HOWARD COUNTY HISTORIC PRESERVATION COMMISSION

June Agenda

Thursday, June 2, 2016; 7:00 p.m.

****Please note the following comments and recommendations are from DPZ Staff and are recommendations for the Commission to consider, they do not represent a decision made by the Commission.****

Figure 14 - Amenity Area site plan

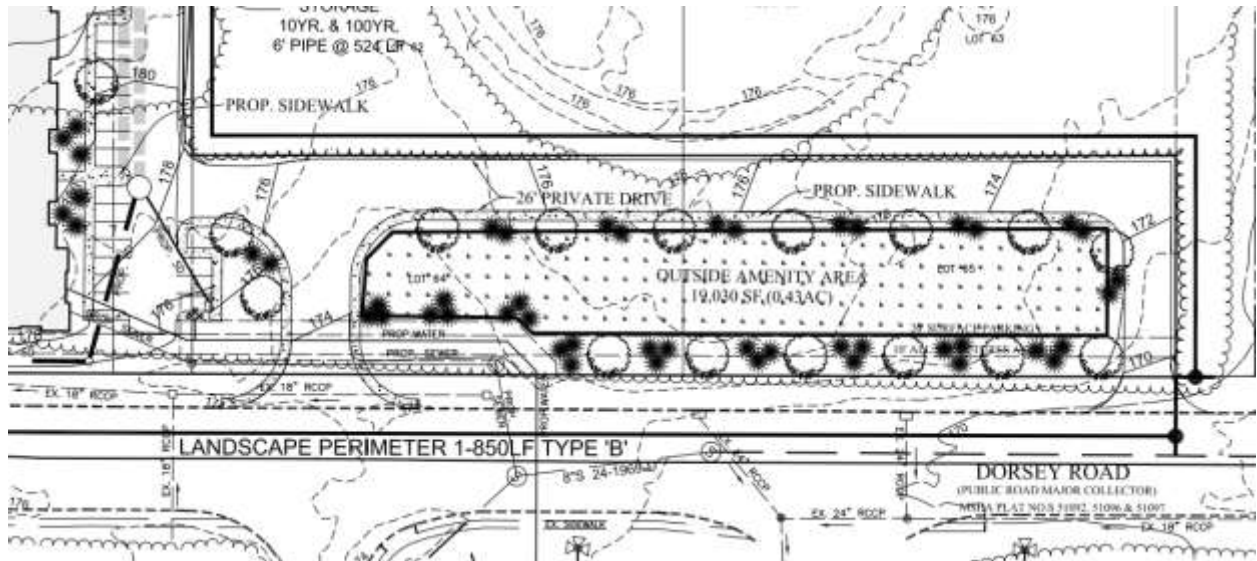
Staff Comments: The proposed entrance and amenity area is currently densely wooded. There are also reports and concerns of possible grave sites being in this area, although none are confirmed. Ground penetrating radar was used on other areas within Rosa Bonheur, but was not an option to use in this wooded area as the results would be inconclusive due to ground disturbance from the dense vegetation. A thorough survey of the wooded area needs to be performed to confirm that there are no burial sites among the trees. This should be accomplished through historical research, a professional evaluation of the area and probing of the area. Section 16.118 of the County Code states, “Cemeteries should be dealt with in accordance with subtitle 13 of this title. In any case, no grading or construction shall be permitted within 30 feet of a cemetery boundary or within ten feet of individual grave sites.” Additionally, Section 16.1304(3)(c) states that the “property owner shall submit to the Department of Planning and Zoning the documentation of the boundaries of the cemetery, and a plan showing how the cemetery will be accommodated with the development and how public access to the cemetery will be provided.” The Applicant should explain how Section 16.1304 of the County Code, Development or subdivision in a cemetery, has been addressed.

There does not appear to be a relationship between the proposed amenity area and the cemetery. Staff would like to see a provision for access to the cemetery from Dorsey Road provided in the event that the Route 1 access to the cemetery is removed in the future due to development and traffic safety enforcement. The site plan also makes it seem that the loop drive in Rosa Bonheur will be slightly disturbed by the construction of the amenity area as the proposed fence and hedge bisect the existing road.

There is a sidewalk shown on part of the amenity area, but it does not continue around the whole area. Staff recommends the sidewalk be continued to create an entire loop for pedestrian use, as this is a proposed amenity area. Pedestrian access and crosswalks should be provided across the new road to guide visitors into the cemetery.

Additionally, the site is part of a cemetery, which should be recognized through the site design. Staff recommends there be signage added recognizing the cemetery and historic site and parking should be available to those wishing to visit the cemetery.

Staff Recommendation: Staff recommends:

- 1) Signage be created and installed for the cemetery.
- 2) An enhanced entryway for access to the cemetery be created.
- 3) A thorough analysis of potential burial sites be researched prior the start of construction.
- 4) The sidewalk be continued around the entire perimeter of the amenity area and include pedestrian access to the cemetery.
- 5) All laws pertaining to the Cemetery Preservation Act of 1993 be followed.

Figure 19 - Proposed alterations

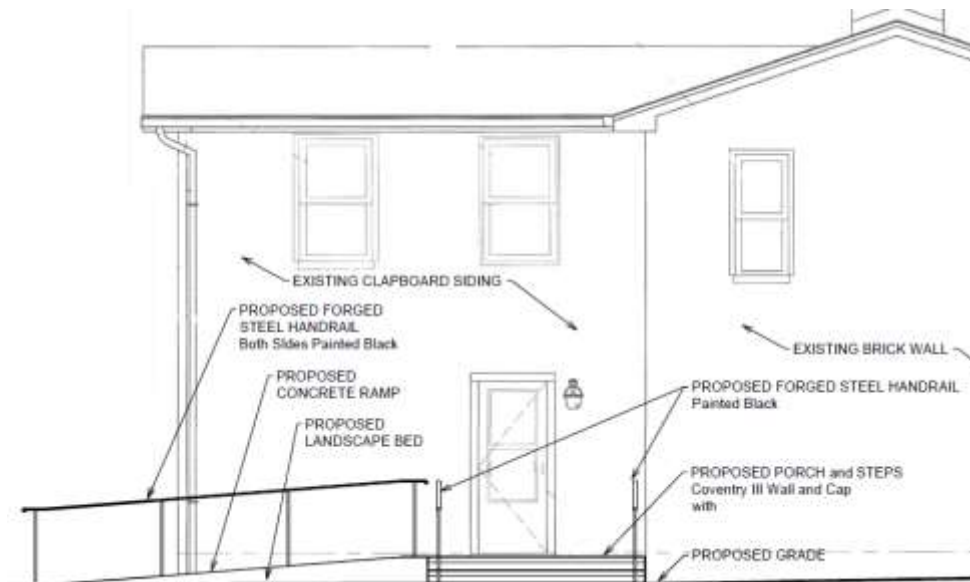
Staff Comments: The proposed changes and existing alterations comply with the Secretary of the Interior Standards for Rehabilitation, “new additions, exterior alterations, or related new construction shall not destroy historic materials, features and spatial relationships that characterize the property. The new work shall be differentiated from the old and shall be compatible with the historic materials, features, size, scale and proportion, and massing to protect the integrity of the property and its environment” and “new additions and adjacent or related new construction shall be undertaken in such a manner, that, if removed in the future, the essential form and integrity of the historic property

and its environment would be unimpaired.” The historic building will not be damaged or irreversibly altered by the construction of the porch, ramp or tent. Additionally, if this building ever reverted back to a private residential use, the items could be removed. The pavers are a modern paver, but are compatible with the historic brick on the building. Black metal railings are frequently used on historic buildings and this railing is very simple in design.

While the tent structure is quite large in comparison to the historic house, it is set off to the side of the house and the view of the house is not disturbed. Vegetative screening has been added against the street. The same materials are used in the tent structure, so all hardscaping on the site is consistent and compatible with the historic building. Staff recommends adding vegetative screening behind the historic house and tent to screen the greenhouses from the viewshed of the historic building and tent.

Staff Recommendation: Staff finds the proposed changes are architecturally compatible with the historic structure as they adhere to the Secretary of the Interior Standards for Rehabilitation. Staff recommends additional landscaping be added to screen the view of the greenhouses.
